# Technical Support Document – CapturePoint Solutions, LLC, Proposed Permit Denial

The following technical support document (TSD) was composed to provide a more detailed explanation of factors related to the proposed denial of the permit applications submitted by CapturePoint Solutions, LLC. A summary of the reasons for denial is contained in the accompanying fact sheet available on <https://www.regulations.gov> under docket #EPA-R06-OW-2024-0583.

**Appendix 2, Figure 10**

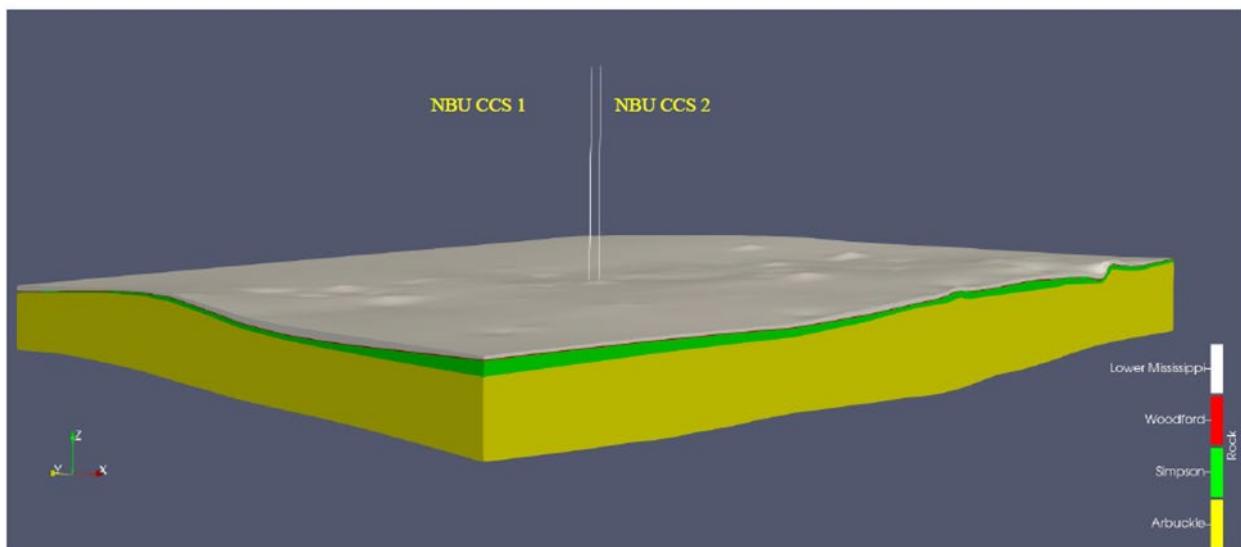
A review of the material submitted (narrative discussion, isopach maps, structure maps, etc.) has concluded CPS did not provide adequate supporting evidence from localized site-specific data to corroborate the assertions that the Woodford Shale and Lower Mississippi has the appropriate sealing properties to be viable confining zones or that the cumulative approximate thickness of 70 feet would be effective confinement to contain any vertical migration of CO<sub>2</sub> to prevent endangerment to underground sources of drinking water. The applicant relied mainly on literature resources and test trial data obtained from a small-scale CO<sub>2</sub> sequestration test field located in Kansas (Wellington Field) to characterize the geologic conditions of the Mississippian. Because of this, the sealing characteristics of the selected confining zones at the injection site cannot be considered regionally equivalent or acceptable to satisfactorily meet the requirements at 40 CFR 146.82(a)(3)(iii) when compared to data obtained from the Wellington Field. Additionally, low shale volume and lack of lateral continuity indicate the Woodford Shale is unsuitable for primary confinement for geologic sequestration.

## Appendix A, Figure A-12

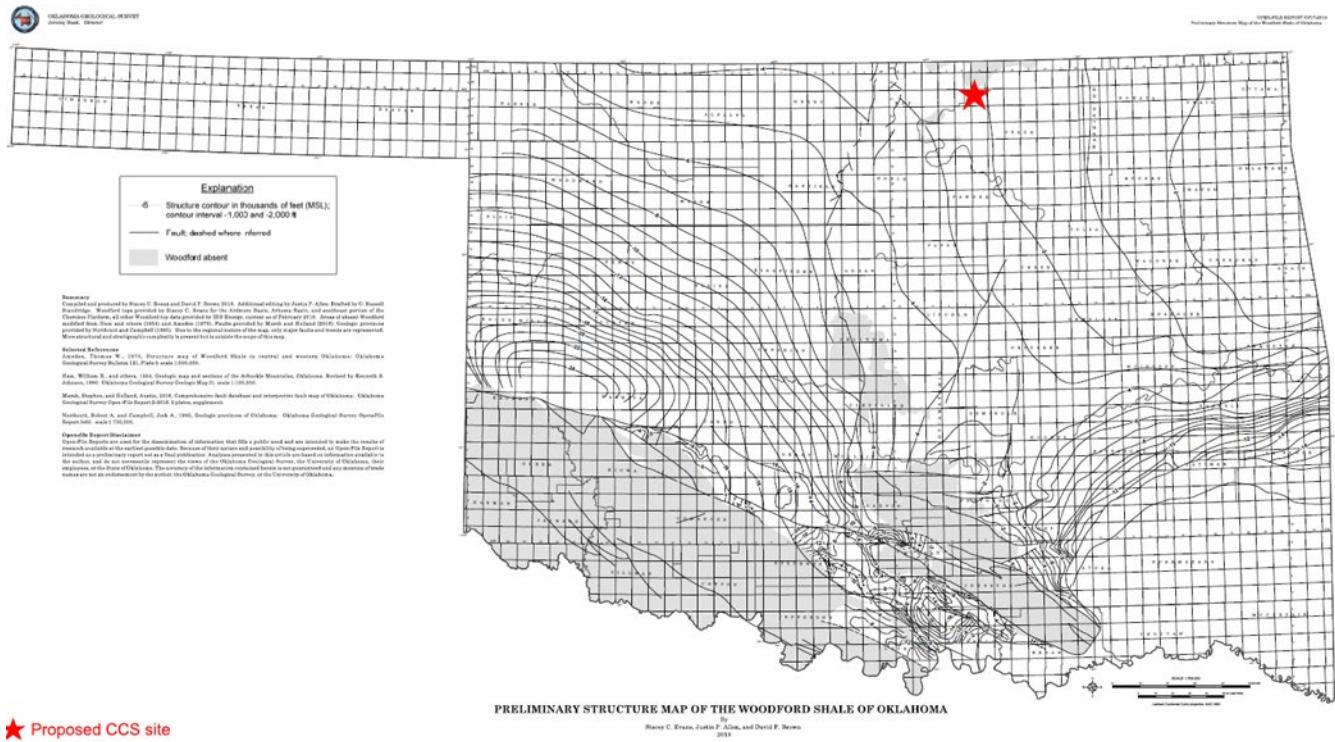
Section 2.3 and subsequent sub-sections 2.3.1 – 2.3.3 (pgs. 27 – 31) provides descriptions of the confining zones at the proposed NBU CCS site. The Woodford Shale, designated as the primary upper confining zone, is approximately 75 feet above the injection zone. As indicated in narrative (pg. 29) the degree of thickness of the Woodford Shale is regionally varied across Oklahoma. In northern Oklahoma, the thickness ranges between 50 -100 feet and 200 – 900 feet in southern Oklahoma (Johnson and Cardott, 1992). However, the thickness of the Woodford Shale at the proposed injection site is approximately 10 feet. The Woodford’s thickness is depicted in an isopach map and 3D model of the stratigraphy in Appendix B, Figure B-11 and Appendix 2, Figure 10, respectively. Additionally, in the northern region of Osage county and areas that are in close proximity to the proposed site, the Woodford Shale is either absent or become increasingly thinner. This deficiency is shown evident on a structure map found in Appendix A, Figure A-12.
